Request	-	Special Use Permit for a Day Care Center
Location	-	2800 W. Central Avenue
Applicant	-	Drew Scott 2800 West Central Avenue Toledo, OH 43604
Owner	-	Beal Investments II LLC P.O. Box 980208 Ypsilanti, MI 48198
Architect	-	Larry Miller 2722 N. Holland-Sylvania Road Toledo, OH 43615

The applicant is requesting a Special Use Permit to operate a Day Care Center at 2800 W. Central Avenue. The ±0.26-acre site is split zoned CO (Office Commercial) and RS6 (Single-Dwelling Residential). A Special Use Permit is required for the operation of a day care center within Residential zoned districts. Surrounding land uses include single-dwelling homes to the north; the Shops at Central Shopping Plaza, automotive repair shop, and used auto sales lot across Central Avenue to the south; St. Andrew's Episcopal Church, Discovery Academy Elementary school, and Toledo Church of Christ to the east; and a medical office, insurance agent offices, Wersell's bike shop and single-dwelling homes to the West. The site is currently occupied by a vacant medical office, which the applicant plans to modify for a day care center.

SPECIAL USE PERMIT
TOLEDO CITY PLAN COMMISSION
REF: SUP25-0018
DATE: July 3, 2

SITE PLAN

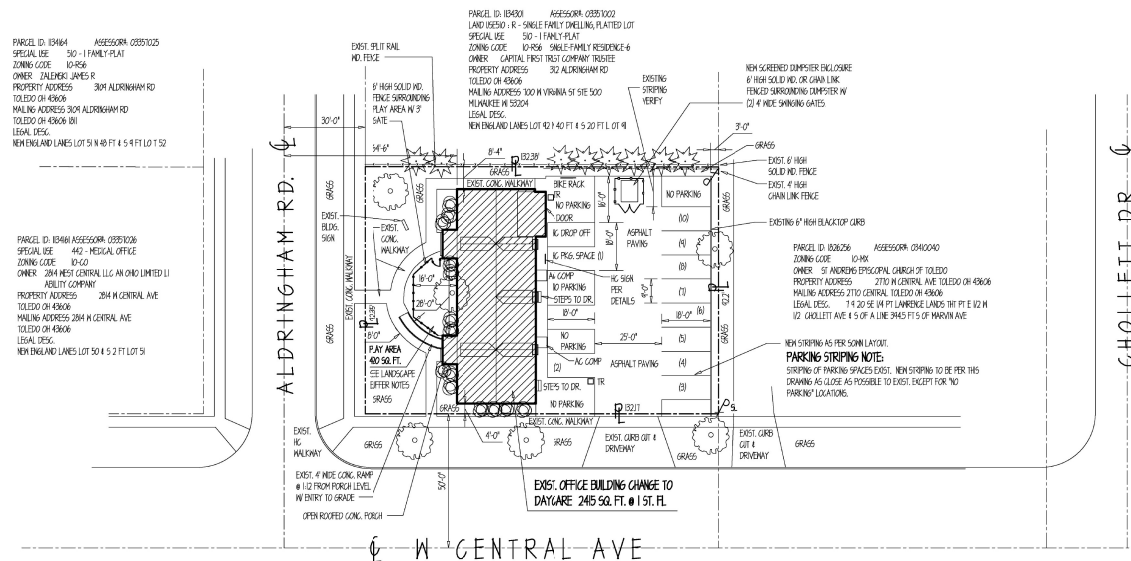
The site plan submitted depicts the outdoor play area on the west side of the property along Aldringham Road. The proposed outdoor play area is fenced in using a six-foot (6') tall solid privacy fence to screen the area. However, per **TMC§1105.0302(A)(1)**, fences shall not exceed three and one-half (3 ½') feet in height in the front yard. **The applicant shall submit a revised site plan with a new location for the outdoor play area, or reduce the height of the proposed fence from six (6') feet to no more than three and one-half (3 ½ ') feet within the front yard.** The site plan also shows seven (7) shrubs and one (1) tree around the proposed play area that are currently existing trees and shrubs on the property. The applicant has the option to request credit for the existing trees under **TMC§1108.0407(B)(9)**. **The submitted site plan does not show details such as species of existing shrubs and plants on site. Applicant shall submit a revised landscape plan with plant details.**

A frontage greenbelt is required along all public rights-of-way per **TMC§1108.0202**. Frontage greenbelts shall be a minimum width of fifteen (15') feet and have at least one (1) tree for every thirty (30') feet of lot frontage. When the parking lot is in the front of the property, the frontage greenbelt shall include a solid evergreen hedge planting to screen the parking lot so that no headlights of vehicles can be seen from the street. The parking lot is along the Central Avenue frontage. Low, undulating earth berms or decorative stone or brick walls, or ornamental metal fencing or combinations thereof may also be approved by the Planning Director as a part of the frontage greenbelt abutting the parking area. **The submitted site plan does not depict a frontage greenbelt, a landscape plan shall be submitted to the Plan Director and is listed as a condition of approval.**

TMC§1108.0204 - *Parking Lot Landscaping*, requires two (2) canopy trees and six (6) shrubs per ten (10) parking spaces to be installed in the interior landscape areas. Trees and shrubs do not need to be equally spaced, and one (1) canopy tree may substitute for three (3) shrubs. Additionally, a perimeter landscape buffer shall be provided abutting the parking area to visually screen all off-street loading facilities from view of Residential districts and public rights-of-way. A minimum of one (1) canopy tree shall be provided for each thirty (30') linear feet, plus a continuous shrub with a minimum height of 18 inches when installed. The parking lot perimeter landscaping width and planting requirements of TMC§1108.0204 when along a public right-of-way will count towards the requirements of the frontage greenbelt (TMC§1108.0202), and when adjacent to another property will count towards the buffer and screening requirements (TMC§1108.0203). **The site plan does not depict parking lot interior nor perimeter landscaping, a revised landscape plan shall be submitted.**

In addition to the required frontage greenbelt, buffer and screening, and parking lot area landscaping; interior site landscaping shall be provided. One (1) two-inch caliper tree for every 1,000 square feet of building coverage, foundation plantings along all portions of the building that are visible from the right-of-way, and landscaping at all major entrances shall be provided. The site plan depicts adequate foundation plantings, however, plantings at the building entrances are not included. The applicant may request credit for existing trees on site per TMC§1108.0407(B)(9). **A revised landscape plan shall be submitted to reflect interior site landscaping requirements.**

- b. Fences shall not exceed three and one-half (3 ½') feet in the front yard. **Not acceptable as depicted;**

- c. A frontage greenbelt shall be provided along all public rights-of-way pursuant to **TMC§1108.0202**. Frontage greenbelts shall be a minimum width of fifteen (15') feet and have at least one (1) tree for every thirty (30') feet of lot frontage. **Not depicted on site plan, shall be submitted on revised landscape plan;**

- g. One (1) two-inch caliper tree for every 1,000 square feet of building coverage, foundation plantings along all portions of the building that are visible from the right-of-way, and landscaping at all major entrances shall be provided. **Not acceptable as depicted. A revised landscape plan shall be submitted to reflect interior site landscaping;**

- k. The location, number, height, diameter and species of any materials to be planted and maintained, as well as the location and number of any existing trees to be retained. **Not acceptable as depicted. Applicant shall provide a landscape plan showing detail of existing and proposed plants.**
